Access Compliance Report

Public Rights-of-Way

(Curb Ramps)

Intersection ID: 51663	Main Street: CORSICA_FOREST_DR	Cross Street: TOSCANA_WY	Location: SE
ADA ID: 9668AFCF85A6	Ramp Type: PerpDiag	Initial Pass/Fail: Fail	Overall Compliance: No
Severity Score: 13.75			
Codes/Mitigation Info/Possible Solution		Field Measurements/Component Compliance

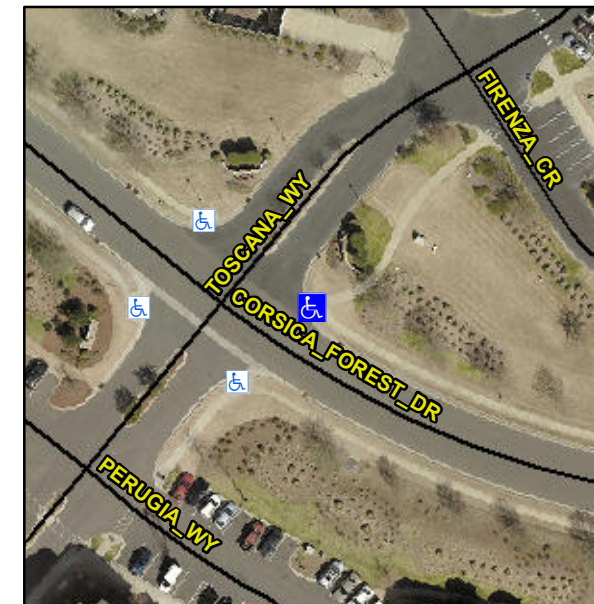
Not Found, R304.2.2, R304.5.3

Compliance	Description	Data	Compliance	Description	Data
N/A	Ramp Length (in)	49.0	No	Ramp Slope (%)	8.8
Yes	Ramp Width (in)	48.0	No	Ramp XSlope (%)	2.2
N/A	Flare Type LT	N/A	N/A	Flare Type RT	N/A
N/A	Flare Slope LT (%)	N/A	N/A	Flare Slope RT (%)	N/A
N/A	Flare Traversable LT?	N/A	N/A	Flare Traversable RT?	N/A
N/A	Landing Length (in)	N/A	N/A	DWS Provided?	N/A
N/A	Landing Width (in)	N/A	N/A	DWS Contrast?	N/A
N/A	Landing Slope (%)	N/A	N/A	DWS Length (in)	N/A
N/A	Landing X Slope (%)	N/A	N/A	DWS Full Width?	N/A
N/A	Landing Curb? (Y/N)	N/A	N/A	DWS Offset (in)	N/A
N/A	Shared Landing?	N/A			
N/A	Gutter Ponding?	N/A	N/A	Gutter Slope (%)	N/A
N/A	Gutter Lip Ht (in)	N/A	N/A	Gutter X Slope (%)	N/A
N/A	Painted X Walk1?	No	N/A	Painted X Walk2?	No
	X Walk 1 Direction	To NW		X Walk 2 Direction	To SW
N/A	X Walk 1 Width (in)	N/A	N/A	X Walk 2 Width (in)	N/A
	X Walk 1 Slope (%)	0.3		X Walk 2 Slope (%)	1.2
	X Walk 1 X Slope (%)	1.9		X Walk 2 X Slope (%)	1.0

Remove & Replace Curb Ramp With Two New Directional Ramps or Equivalent.
